**Content Programmed repairs Front axle**

### 33 Front axle

#### Modified mounting (2-piece)

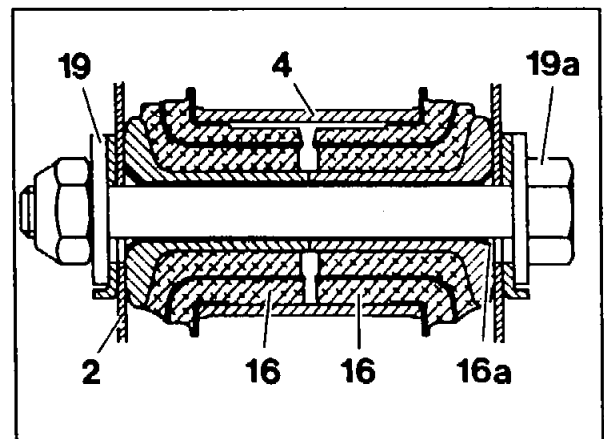
| 33-87067 | Entire vehicle shakes and torsional oscillations at steering wheel. | Model 124 up to 03/87 |

Since March 1987 (phased in) a modified control arm mounting has been installed on the front axle. The control arm has a two-piece mounting of high-damping torsion rubber elements at the front and rear. The distinguishing feature is the rear control arm mounting. This damps the vibration of the vehicle and torsional oscillations of the steering wheel..

Vehicles with rubber mounts of the 1st version must be converted to the modified mounting in accordance with operation no. 33-0526.
